DISPUTE REVIEW BOARD RECOMMENDATION

RE: SR 91 AT CR 470
FIN No.: 404214-1-52-01
County: Lake
District 8
Disputes Review Board

DISPUTE: Differing Soil Conditions – Pond 2.

- The plan sheet 160 for Pond 2 does show borings within the pond:

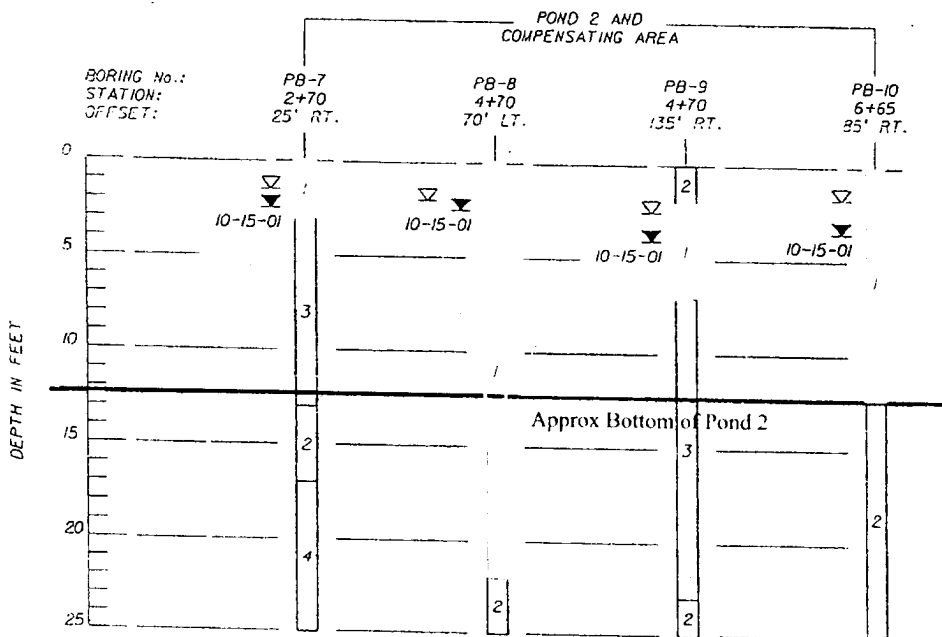
*SOIL BORINGS -- The contract plans, Sheet 160 has the boring locations, **Sheet 169 has the pond auger boring soil classification.***

*The contract-plans show four (4) borings taken in Pond No. 2, PB-7, PB-8, PB-9 and PB-10. These boring indicate approximately 70 % of the material in Pond No. 2 classified as A-3 material. **During excavation of Pond No. 2 approximately 4,000 cubic yard of A-3 material was found (4.9%).***

- The plan sheet 169 - Pond Auger Borings shows the depth of the various strata within the pond:

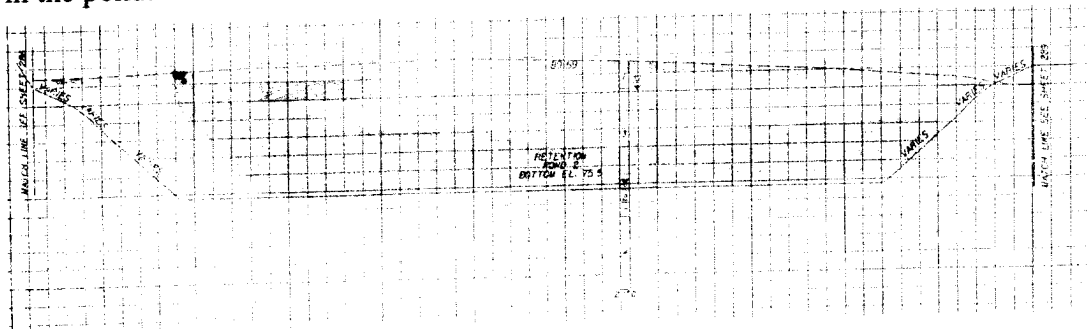
- Strata 1 is identified as “LIGHT GRAY TO BROWN TO DARK GRAY FINE SAND WITH SILT (A-3)”. The note at the bottom alerts the reader to the fact that this determination was by visual examination.

- While the Pond 2 Auger Borings are variable, **the Contractor could have reasonably expected to find A-3 material.**
- The Contractor did not furnish his method of calculating that there was 70 % A-3 material represented in the plans.

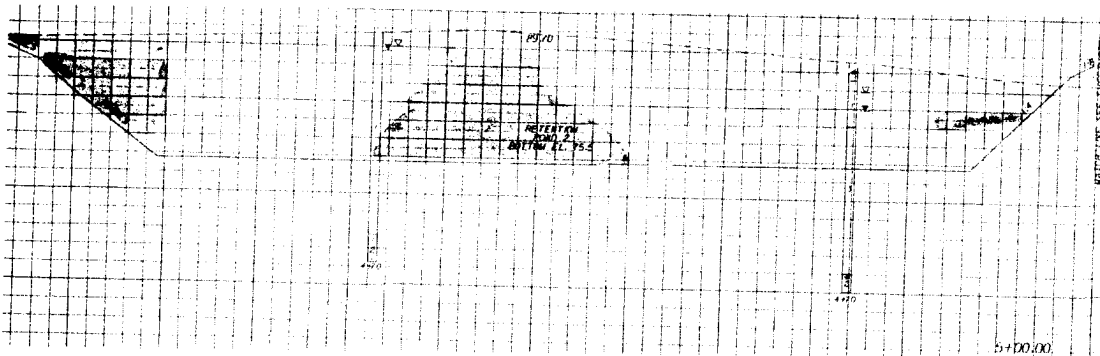
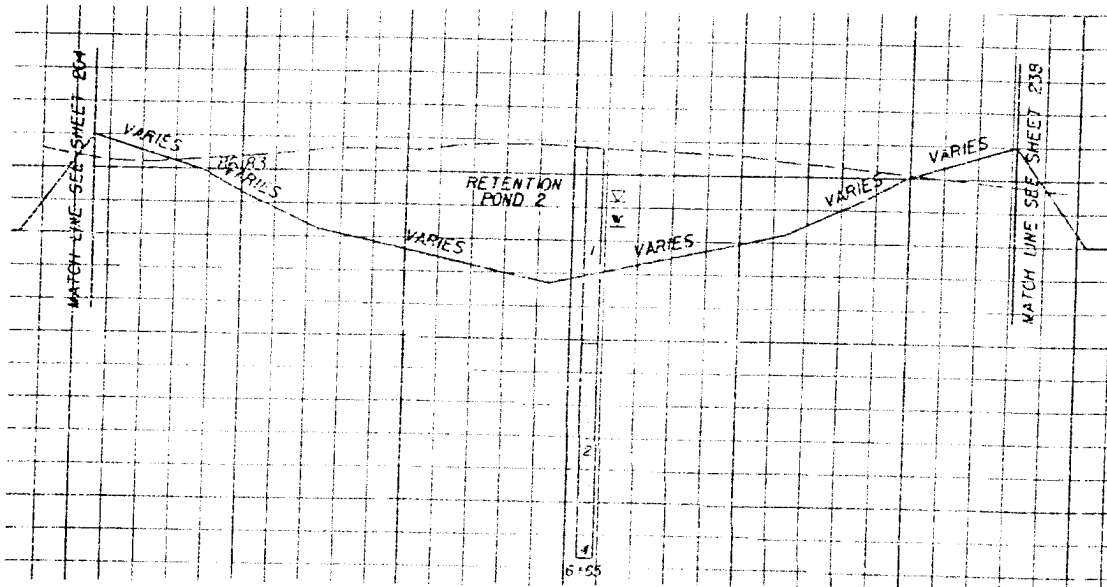
The following cross section plan sheets¹ of Pond No. 2 shows the strata encountered as observed by KCCS during excavation of the pond. Pond No. 2 was made up primarily of two different materials. A mix of dark brown, light brown and tan sand (A-3) with areas of orange and red clayey sand (A-2-6) to sandy clay (A-2-4), with varying degrees of sand and silt throughout the stratum. The blue colored portion of the sheets represent the organic topsoil layer, yellow represents the brown and tan sandy areas of the pond (A-3) and the orange represents the orange, red clayey sand to sandy clay areas (A-2-6 and A-2-4).

- On the Roadway Soil Survey (Sheet No. 165) Stratum No. 1 is also identified as A-3 with 4-10 % passing 200 mesh. The soil classification of A-3 on the Auger Borings above was by “visual examination”.
- Marked up cross sections provided by the CEI further indicate the presence of A-3 material in the pond:
